# GLENVIEW PUBLIC SCHOOL - GYM ADDITION

CITY OF BURLINGTON  
BUILDING SERVICES  
REVIEWED  
FOR PERMIT ISSUANCE  
DATE July 10/2024  
PERMIT NUMBER 24 008616  
EXAM Ark

ISSUED FOR BUILDING PERMIT SUBMISSION

**ALL FOOTING INSPECTIONS SHALL BE PERFORMED BY  
GEOTECH. ENGINEER BEFORE POURING CONCRETE.  
PROVIDE REPORT TO BUILDING INSPECTOR.**

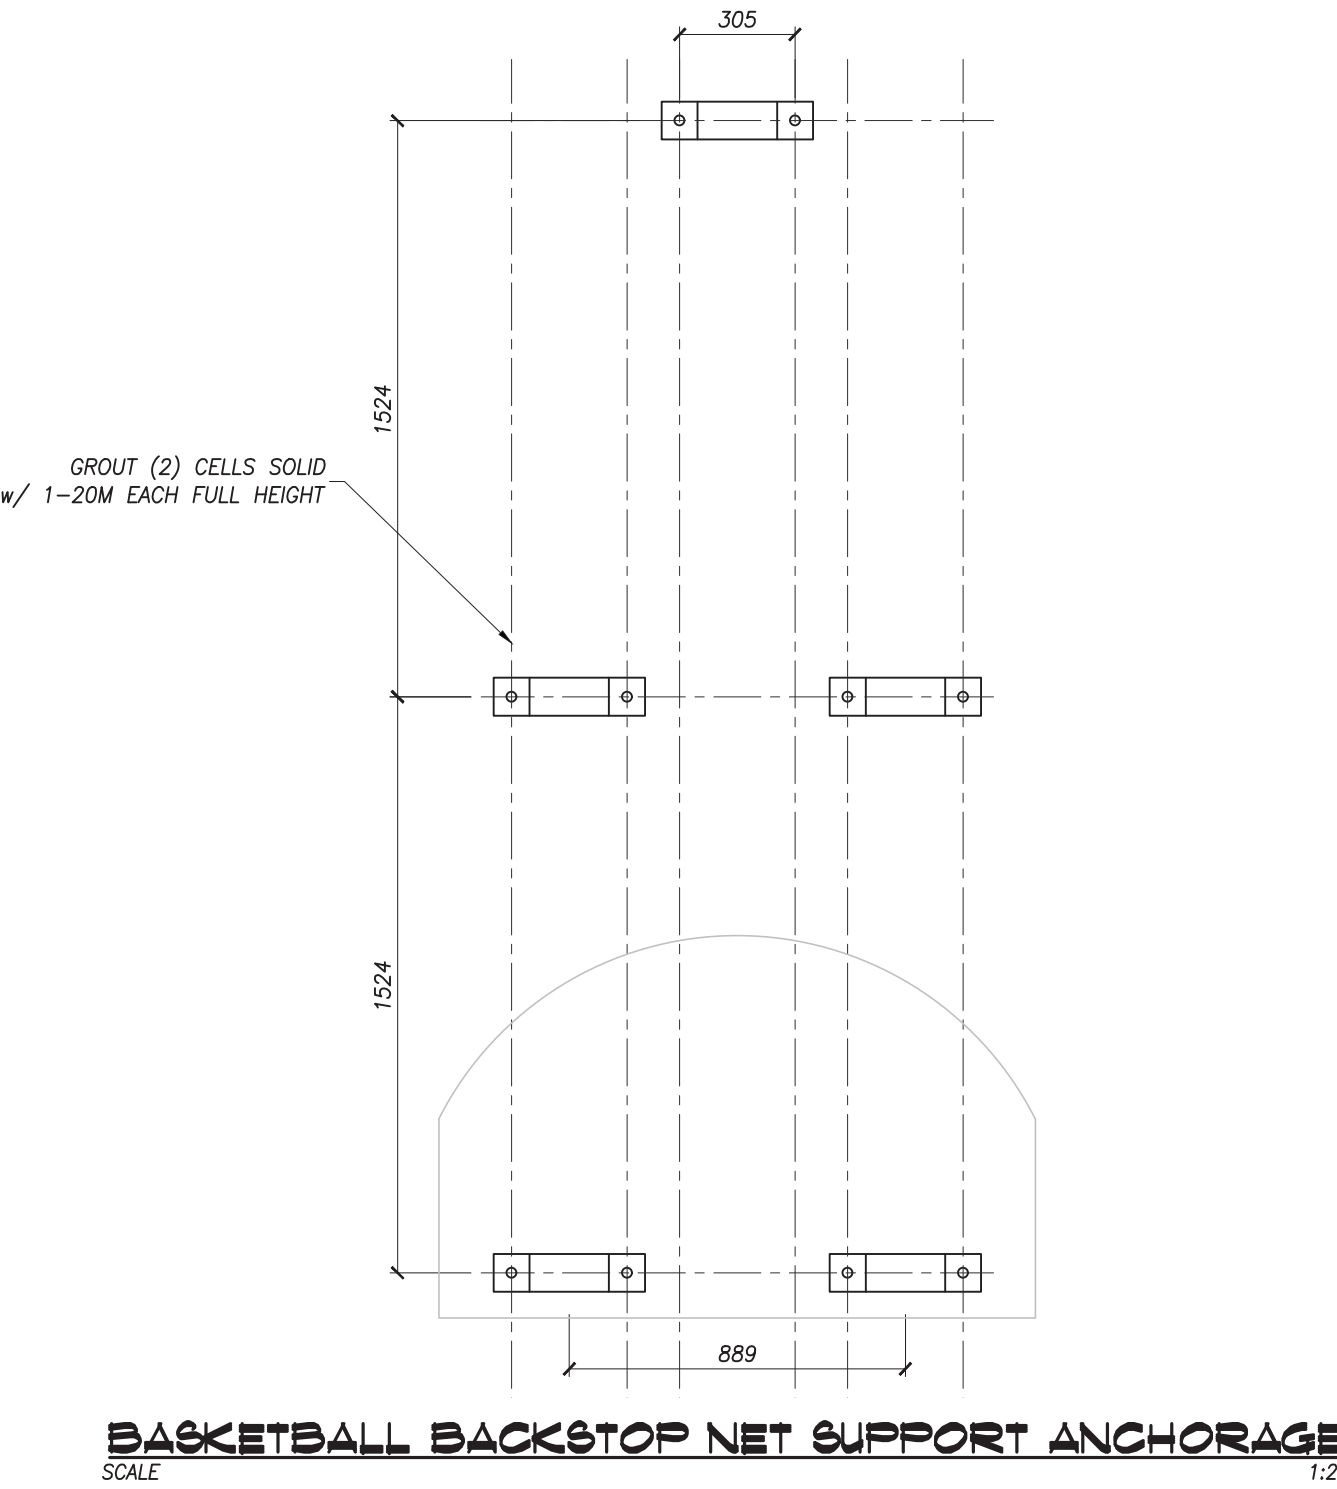
Provide safety cage around ladder as per Ministry of Labour requirement. Please see attached document/specifications.
